## **APPENDIX A**

13 April 2022 (These notes were amended 6 June 2022 to reflect changes made by the applicant subsequent to the 19 April meeting. See Notes on pages 2, 3, 9, 10, 12, 15, 17, 22, 25, 29 & 30.)

Following OGNED's meetings before the Historic Preservation Commission (HPC) on 6 & 27 April 2021, three members—Deborah Osepchuk, Lucinda Heinlein, and Jeffery Rudell—were asked by Bernie Haney, to meet and offer feedback to the development team on ways their application (the Plan) could be brought into conformity with the Architectural Design Guidelines (Guidelines). These meetings were similar to the informal weekly Tech Review meetings available to all applicants to the HPC.

Illustration B.11. — East elevation of proposed pediment-topped entry to courtyard corridor (Sheet A-5).

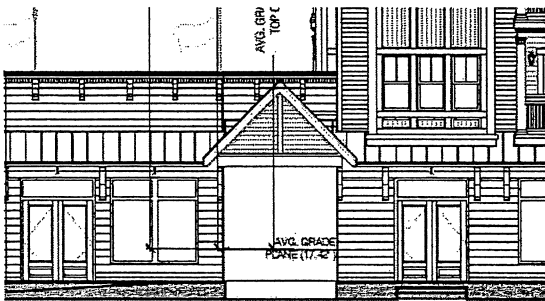
**B.11. — Courtyard Corridor:** At Tech’s request, OGNED agreed to reconsider the access corridor that leads from the boardwalk to the interior courtyard, to better highlight the access point and make it look more like a feature of the Retail frontage and less like an alley. At present, the pedimented entry has little relationship to the rest of the Retail area or the boardwalk itself. Tech asked OGNED to consider ways to extend that entrance forward (as a pergola or other structure extending toward the boardwalk) to better invite pedestrians into the space. The Plan presented did not activate courtyard access in any way, provided no shade, and seemed “uninviting.” No change to this area is reflected in the current Plan. **NOTE: 3 June 2022**  
Summary of Changes: Windows provided in the retail spaces on both sides of the corridor passageway.

**B.12. — Courtyard Corridor:** Is the entrance to the courtyard at grade (at boardwalk level) or raised to the level of the sidewalk that runs in front of the Retail? If at grade, what accommodations are made to access the courtyard entrance from the raised sidewalk? Also, will the handicap accessible ramp necessitate closing off the sidewalk with a railing where it meets the corridor entrance? (See Illustration B.11., above.)

**CHANGE MADE AS NOTED. ADDITIONAL MULTIPLE CHANGES WERE MADE AT THE REQUEST OF THE HPCE INCLUDING CHANGES TO THE GABLE END ROOF PROJECTIONS AND THE ADDITION OF WINDOWS ALONG THE CORRIDOR TO ENLIVEN THE LOCATION AS RETAIL SPACE.**

**ADA ACCESSIBILITY PROVIDED ON PLANS AND IN COMPLIANCE WITH THE BUILDING CODE.**

Illustration C.3. — South elevation of the Hotel showing proposed diamonds and banding on tower roofs (Sheet A-11).

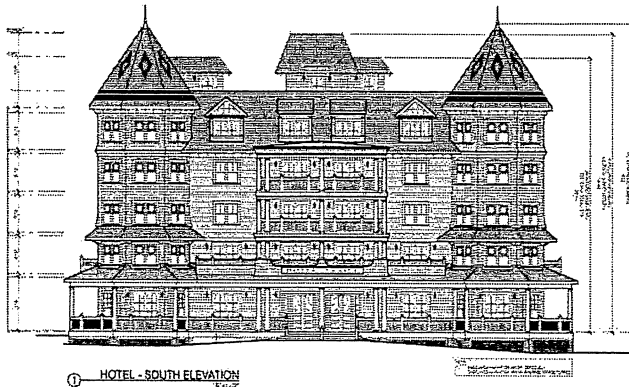
C.3. — **Hotel: Tower Roofs.** The two towers are decorated with over-scaled diamond shapes and wide banding (both created using contrasting roof shingles). Tech found these decorative elements “Disney-esque” in scale and out of character with more nuanced rooftop articulation typical of historic buildings.

THE SCALE OF THE DIAMOND PATTERNS WERE REDUCED ON THE SETTLEMENT PLANS.

Illustration C.4.a. — South roof elevation of the Hotel (Sheet A-11).

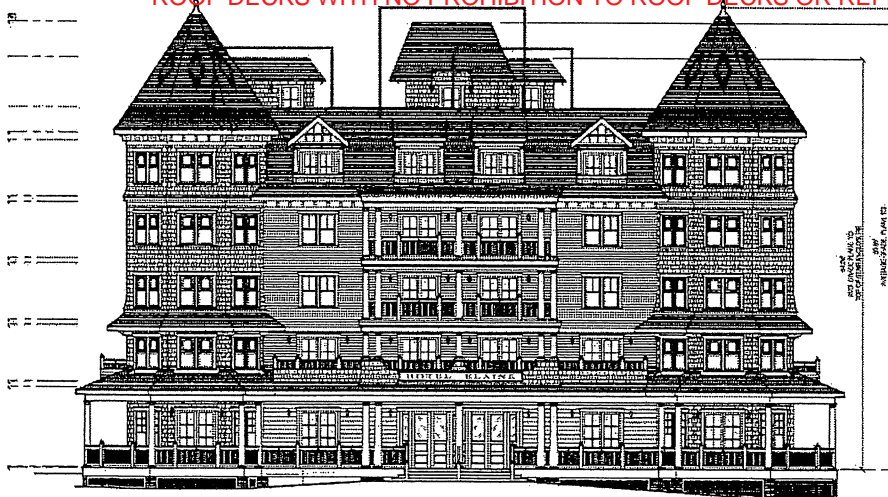
**C.4. — Hotel: Roof Projections.** A central elevator meant to serve a non-conforming roof deck results in a mechanical projection that rises above the level of the parapet roof. While this projection is not expected to be visible from streets immediately surrounding the Hotel, it will be visible from Ocean Avenue as it approaches the Hotel from the south. Likewise, it will be visible from most of the Ocean Grove beach to the south and east of the building. This projection would not be unnecessary were it not for OGNED's intention to provide access to a non-conforming roof deck.

THE ELEVATOR TOWER WAS REDESIGNED PER THE HPC SUGGESTION ON THE REVISED PLANS. APPLICANT CONTINUES TO CONTEND THAT THE DESIGN GUIDELINES DO NOT PROHIBIT ROOF DECKS. SEE SECTION N OF THE RESIDENTIAL GUIDELINES PROHIBITING CERTAIN TYPES OF CONSTRUCTION ON ROOF DECKS WITH NO PROHIBITION TO ROOF DECKS OR REFERENCE TO USE. THE COMMERCIAL

GUIDELINES ONLY LIMIT TV SATELLITE AND OTHER MECHANICAL DEVICES ON ROOFS TO BE SHIELDED FROM PUBLIC VIEW. NO OTHER PROHIBITION OR REFERENCE TO USE.

Illustration C.5.a. — West roof elevation of the Hotel (Sheet A-12).

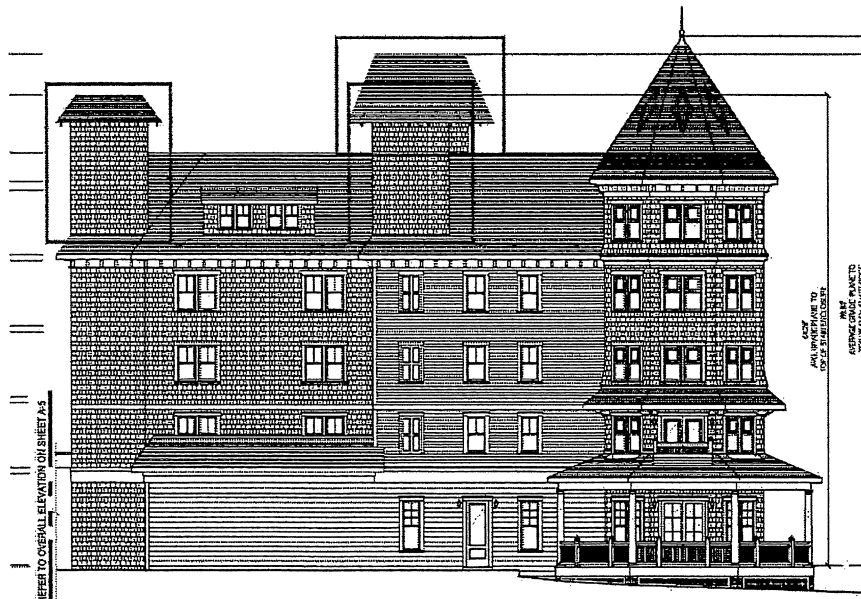
C.5. — **Hotel: Roof Projections.** Two staircase towers also serve the non-conforming roof decks and present similar design non-conformities as a result. **INFORMATIONAL. NO CHANGE REQUIRED.**

Illustration C.10.c. — East elevation of Hotel tower, second floor, showing corbels suggested for use in dormers (Sheet A-11).

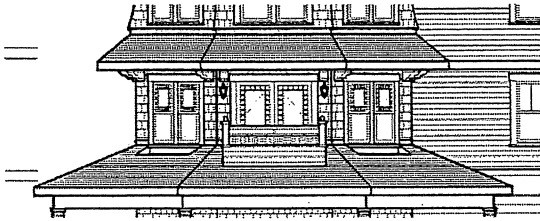
C.10. — **Hotel: Dormers.** Use of Tuscan columns on roof dormers on the south and east elevations are inappropriate. Properly scaled corbels, similar to those used at the tower balconies below the pent, are more appropriate and would help unify the design through repetition. **NOTE:** 3 June 2022 Summary of Changes: *Revised detailing at roof-top dormers. Half-size columns removed and replaced with large brackets. Dormer roof changed from shed to gable to accommodate the revised detailing. Dormer width enlarged to accommodate (1) wall lantern on each side of the doors.* **CHANGE MADE AS NOTED.**

Illustrations C.11.a. and C.11.b. — The north and west elevations of the Hotel showing proposed, non-conforming, double dormers (i.e., pop-ups) (Sheet A-12).

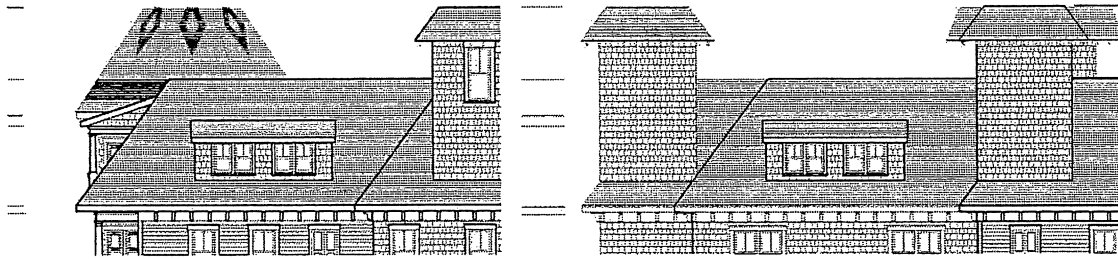
**C.11. — Hotel: Dormers.** The double dormers on the north and west should be changed to conforming individual dormers. Also, these dormers appear smaller than those at the south and east, perhaps due to them containing only windows and not doors. Please clarify.

Illustrations C.14.a., C.14.b., C.14.c., and C.14.d. — The north, south, east, and west elevations of Condominium Building One showing non-conforming faux-gables, balusters and rails, cupola, and stair towers (Sheets

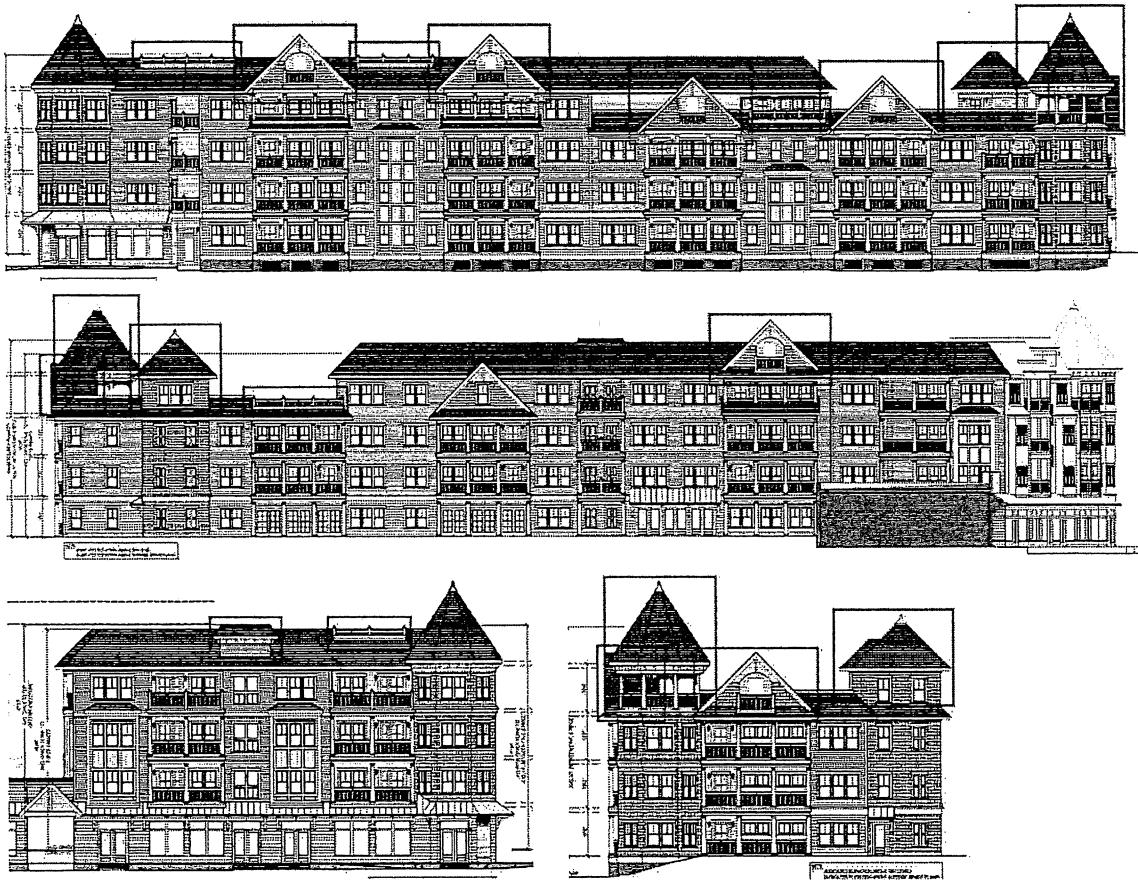
C.14. — **Condominiums:** Rather than strong, historically appropriate, roof forms, the Condominium buildings display disparate architectural elements that fail to unify or strengthen the design. These include a parapet roof meant to suggest a faux-Mansard roof, railing breaks in the parapet with short runs of newel posts and balusters, (that work against the faux-Mansard illusion), stair towers at the east and west elevations that penetrate the parapet, and unusual, non-historic faux-gables with cut-out openings, that further emphasize the non-historic roof treatment. NOTE: 3 June 2022 Summary of Changes: *Sidelights removed on porches/balconies. Removed all visible roof railings on North and East Elevations. Removed visible roof railings on Building Two. Finials added to the towers. Roof top dormers (on 3-story portion of the building) increased in depth. Roof top dormers on Building Two increased in depth.* ALL CHANGES MADE AS NOTED.

Illustration D.4. — East elevation of Condominium Building One (Sheet A-5) showing single balcony doors with non-conforming single side-light windows on each of the six balconies. These balcony doors should match single balcony doors on other elevations and should not include side-light windows.

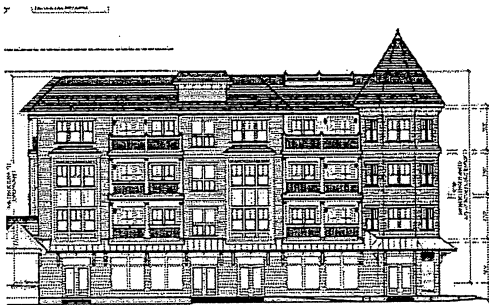
**D.4. — Condominiums:** The east elevation of Building One show single balcony doors flanked by single sidelight windows. Single sidelight windows are inappropriate. These doors should match the single doors found elsewhere on Building One and Building Two. **NOTE: 3 June 2022 Summary of Changes: *Sidelights removed on porches/balconies. Single french door centered in each bay with a single light fixture located on the latch side of the door.***

**CHANGE MADE AS NOTED.**

Illustration E.3.b. — First floor, west elevation of the Hotel showing inappropriate Colonial Revival windows (Sheet A-12).

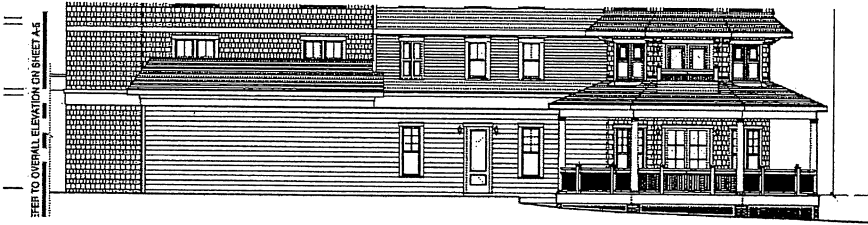
E.3. — **Hotel:** Proposed first-floor windows are 6/1, Colonial Revival style. Such windows have no correlation to a Queen Anne design and fall outside the period of significance. Windows with a 2/1 pane configuration are more appropriate. (See Guidelines, page 18, 5: "Retain or replicate the glazing configuration(s) as per the original or otherwise determined to be historically appropriate...") **REVISED PLANS SHOW 6/1 DOUBLE-HUNG WINDOWS ON FIRST FLOOR REPLACED WITH 2/1 DOUBLE-HUNG WINDOWS.**

Illustration E.6. — West elevation showing proposed rear fenestration of Retail shops (Sheet A-5).

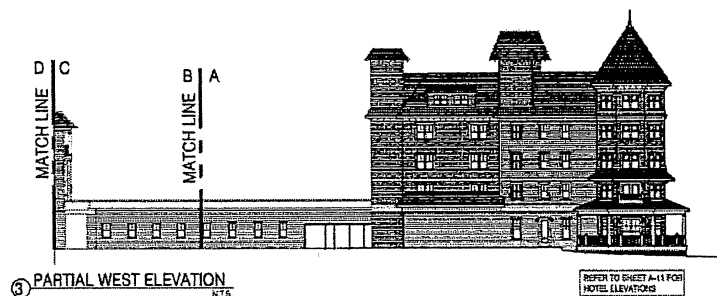
E.6. — **Retail:** Sheet A-5 show single 2/1 windows along the west elevation of the Retail spaces. Are these windows placeholders? Are rear access doors proposed for Retail shops?

REVISED PLANS SHOW DETAILS OF WINDOWS AND DOORS ON RETAIL SPACES. REAR ACCESS DOORS ADDED.

Illustration E.10. — West elevation of Condominium Building Two (Sheet A-8).

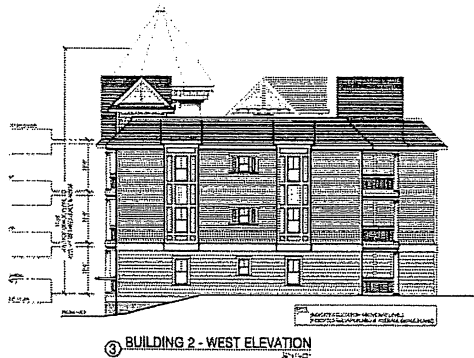
Lake Avenue on the Asbury side of Wesley Lake. Tech considers this elevation under-designed, un-historic, and in need of redesign.

ON THE PLANS FOR SETTLEMENT, "FLOATING" PROJECTIONS ON THE WEST ELEVATION WERE REMOVED BY FILLING IN THE FLOOR PLAN WITH ANOTHER LEVEL OF BAY WINDOWS DOWN TO GRADE LEVEL.

Illustration F.1.b. — North elevation of Condominium Building One showing proposed clapboard reveal at first floor (wide) and upper floors (narrow) (Sheet A-6).

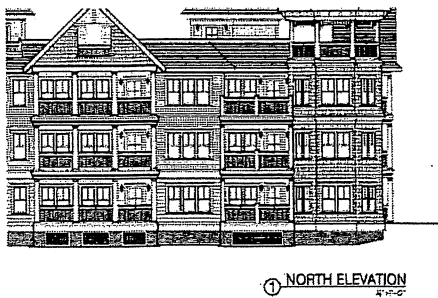
F.1. — **Hotel & Condominium Siding.** The Plan proposes cladding the Hotel with Hardie Plank with two different clapboard reveal dimensions: wide on the first story and narrower on the upper stories. Mixing clapboard reveal sizes is sometimes found on historical examples, but only rarely, and only to highlight important architectural features. No such highlighting of architectural features is present in the proposed Plan. Uniform dimensions of clapboard reveals should be used, instead.

**PLANS FOR SETTLEMENT SHOW CLAPBOARD REVEAL CONSISTENT ON ALL ELEVATIONS.**

Illustrations F.2.a. and F.2.b. — The west and north elevation of the Hotel showing secondary planes covered in shingles (Sheet A-12).

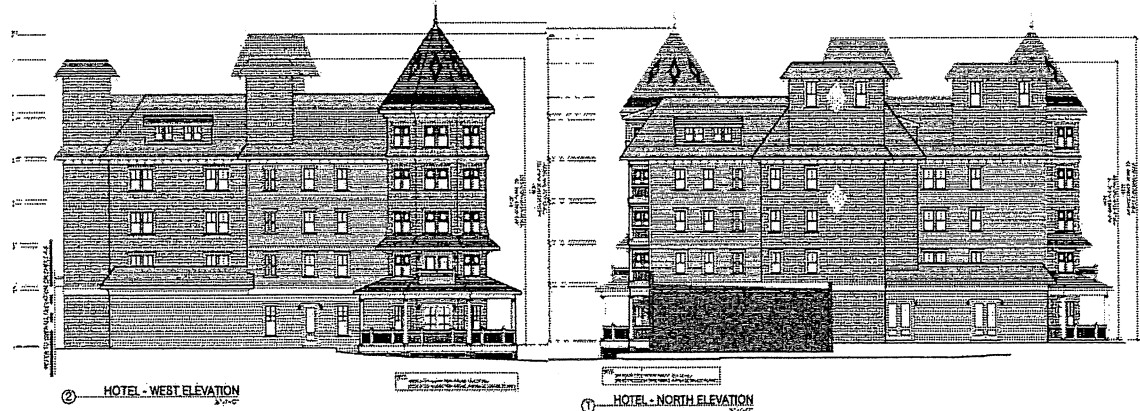
F.2. — **Hotel: Siding.** Cladding the two hotel towers in shakes seems appropriate. However, elsewhere on the Hotel shakes are applied in unusual and confusing locations, including on the rear of the building (as seen on the north and west elevations), and on the two staircase towers. Cladding prominent and important projections, such as inset-balcony stacks and towers, might make sense. However, the over-use of shakes on secondary elements is inappropriate, detracts from more important projections, and is not in keeping with the Queen Anne design.

noticeable on the west and north elevations. This should be addressed. (See illustrations F.2.a. and F.2.b., above.) **ON THE PLANS FOR SETTLEMENT, BANDING WAS ADDED BETWEEN THE 3RD AND 4TH STORIES ON THE NORTH AND WEST ELEVATIONS.**

ON THE SETTLEMENT PLANS, THE SHAKES WERE REMOVED FROM ALL EXTERIORS EXCEPT FOR THE HOTEL TOWERS AND PROMINENT AND IMPORTANT PROJECTS SUCH AS INSET BALCONY STACKS AND STAIR TOWERS.

Illustration F.4. — North elevation of the Hotel showing over-sized diamond patterns in shingled cladding. (Sheet A-12).

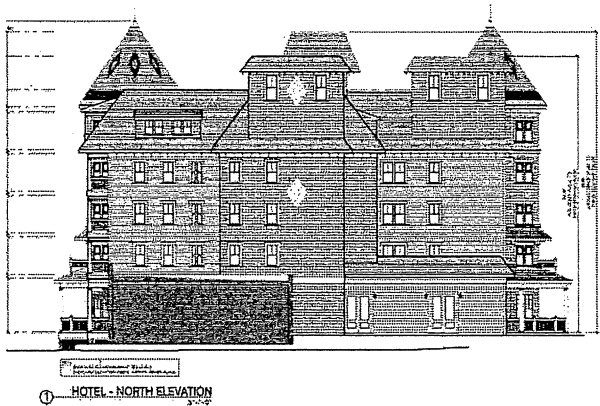
F.4. — **Hotel: Siding.** At the north elevation two “diamond” details are indicated in the proposed shakes. The size of the diamonds is excessive and the location awkward: in the fifth story staircase tower the diamond appears crowded and crammed near the roofline; on the blank wall further down the tower, the diamond is oddly aligned and oversized. Both diamonds should be eliminated or reconsidered in more historic scale and placement. **NOTE: 3 June 2022 Summary of Changes: North Elevation. Reduced the size of the diamond shingle pattern by 20%.**

**CHANGE MADE AS NOTED.**

Illustration G.4.a. — Second floor plan of Condominium Building One showing hybrid inset balconies at all four elevations (Sheet A-2).

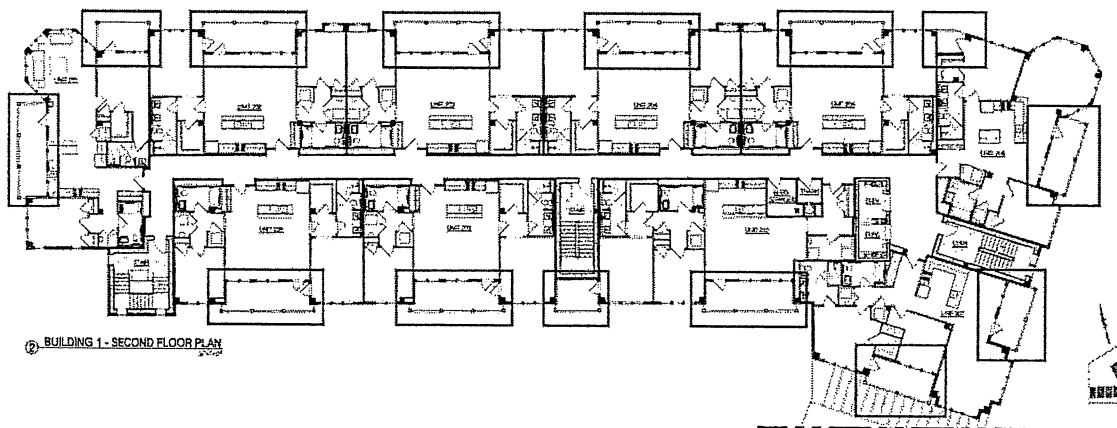
G.2. — **Condominiums:** Inset balconies are counter-historical, especially when used in place of porches. Porches usually project from a building face, provide a human scale to buildings by visually stepping down in size from the body of a building, and add visual interest to buildings by relieving visual mass. Porches enhance a sense of community and promote interaction between a building and its surrounding streetscape. Inset balconies are carved into buildings, are often cut off from the surrounding streetscape, and do not promote interaction. OGNED offers neither strict porches nor strict inset balconies, but rather hybrids where the majority of the open-

air spaces are inset into the body of the buildings with minimal extensions. These limit the change in plane of the buildings, contribute to the visual mass of each structure, and inhibit the sense of community that is vital to Ocean Grove. Tech considers these hybrid balconies non-historic and non-conforming. **NO CHANGE MADE TO BALCONIES.**

Illustrations G.5.a. and G.5.b. — Detail of northeast corner of Condominium Building One showing windowless mini-balconies above the north building access door (Sheet A-6). These balconies are circle in the second-floor plan, at right (Sheet A-2).

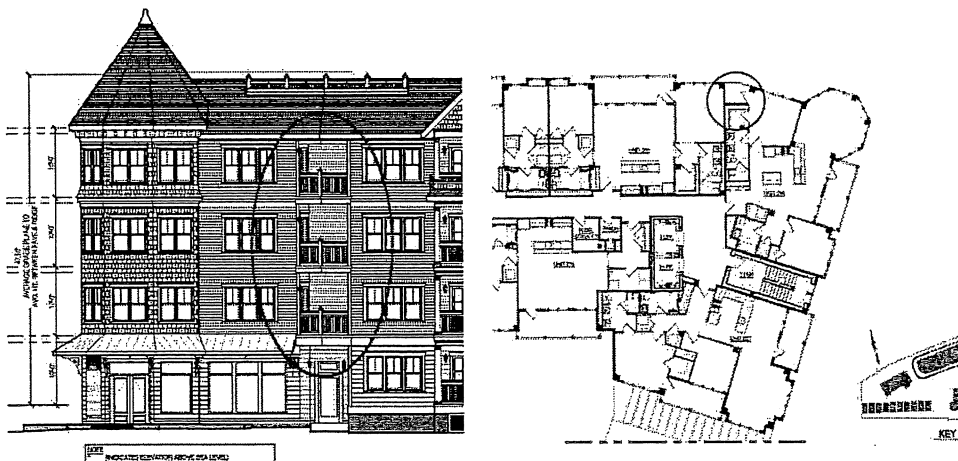
G.5. — **Condominiums:** At the north elevation, just west of the Building One tower, above the north access door, are a row of inset-balconies. These balconies occur at the point where the building jogs southwest along Wesley Lake. These balconies are five-sided, due to a bend in their railings, have no windows, single doors, and no lighting. They are non-historic in character, awkward in size and placement, and differ in every way from any other balcony in the project. Tech recommends they be reconsidered or eliminated. NOTE: 3 June 2022 Summary of Changes: *Shutters added at inset balcony on the North East corner.*

CHANGE MADE AS NOTED.

Illustration H.3. — Roof tile patterns showing oversized diamonds and banding (Sheet A-11).

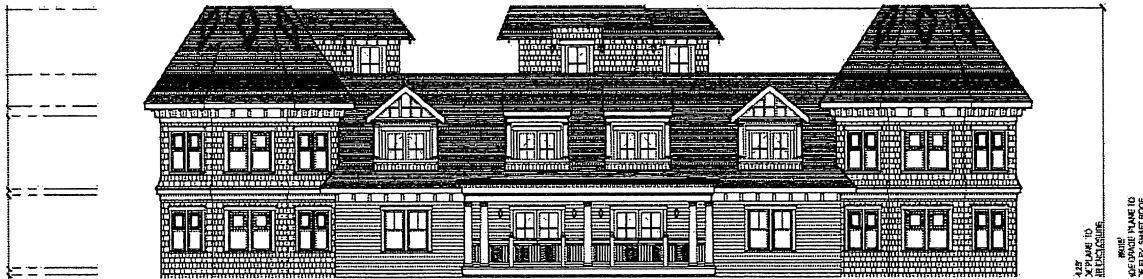
H.3. — **Hotel:** Diamonds and banding on tower roofs is over-scaled. **AS STATED ABOVE, DIAMOND SHINGLE PATTERN REDUCED BY 20%.**

Illustration H.6. — Plan showing proposed Condominium Building One roof path and roof deck (Sheet A-4).

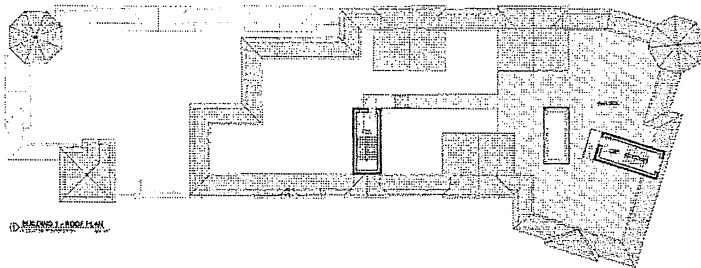
H.8. — **Condominiums:** Are railings proposed for the rooftop pathway and roof deck of Condominium Building One? Please provide cat/cut for review. **RAILING DETAIL FOR ROOFTOP PATHWAY AND ROOF DECK ADDED TO PLANS FOR SETTLEMENT.**

Illustration N.1.a. — Proposed coverage of Hotel Roof deck (emphasis added) (Sheet A-10).

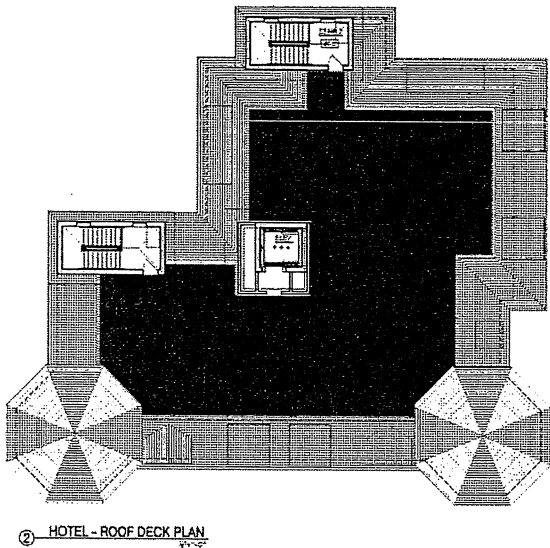
N.1. — **Roof Decks.** The Hotel & Condominium Building One each have large-scale, public roof decks. Condominium Building Two has three private roof decks. Roof decks are non-conforming with the Guidelines. The roof decks proposed are visible in so far as railings and balusters along the parapet provide “viewing platforms” (some beneath the proposed faux-gables). These breaks in the parapet reveal the presence of the roof decks. There is a reasonable expectation that appurtenances related to roof decks (umbrellas, tents, pergolas, rooftop plantings, lighting, etc.) will further reveal the presence of these roof decks atop these buildings. (See, Guidelines, page 27, Section N, “Roof top construction featuring sun decks, swimming pools, and hot tubs are not in keeping with the designs of the Victorian Era nor other historic styles of architecture within the Ocean Grove Historic District. Therefore, such features will be viewed contrary to the “Spirit” of the architectural setting. Introduction of any such feature must fully demonstrate that such a feature would be designed so as not to be visible to public view...”)

PLANS COMPLY IN THAT NO ROOF TOP CONSTRUCTION FEATURING SUN DECKS, SWIMMING POOLS OR HOT TUBS ARE PROPOSED. ROOF DECK USE IS RESTRICTED BY DEED AS PART OF SETTLEMENT ALTHOUGH APPLICANT CONTINUES TO CONTEND THAT USE IS NOT WITHIN HPC JURISDICTION.

Illustration P.1. — South elevation of the Hotel showing proposed signage (Sheet A-11).

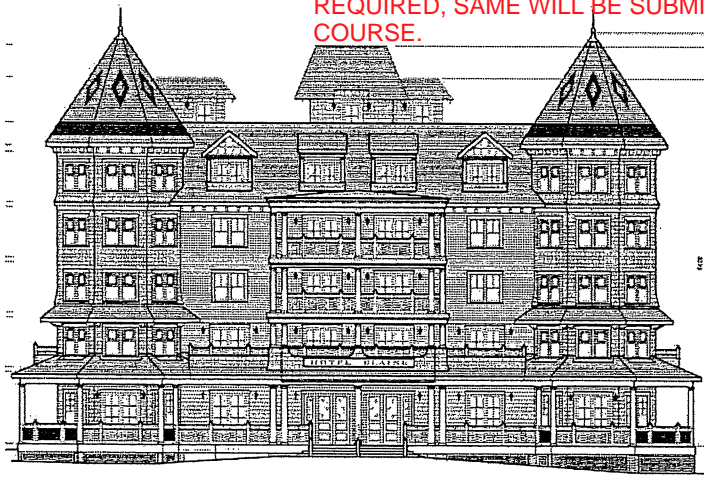
P.1. — No signage schedule was submitted for review by Tech. Excluding the name of the Hotel, which appears on the south elevation (see illustration, below) the current Plan is missing any indicators of type, style, or location of signage on, or around, any of the proposed structures. (See, Commercial Guidelines, Section Q, pages 20-23, "Signs are one of the most prominent visual elements on the street and define the purpose of a building. If designed, signs add interest and variety to the streetscape and building facade while enlivening the street scene. Poorly conceived signs may also detract from the architecture and negatively impact even the best designed storefront...).

ALL KNOWN SIGNS WERE PRESENTED TO THE HPC. SHOULD ADDITIONAL SIGNAGE BE REQUIRED, SAME WILL BE SUBMITTED FOR REVIEW AND APPROVAL IN THE NORMAL COURSE.
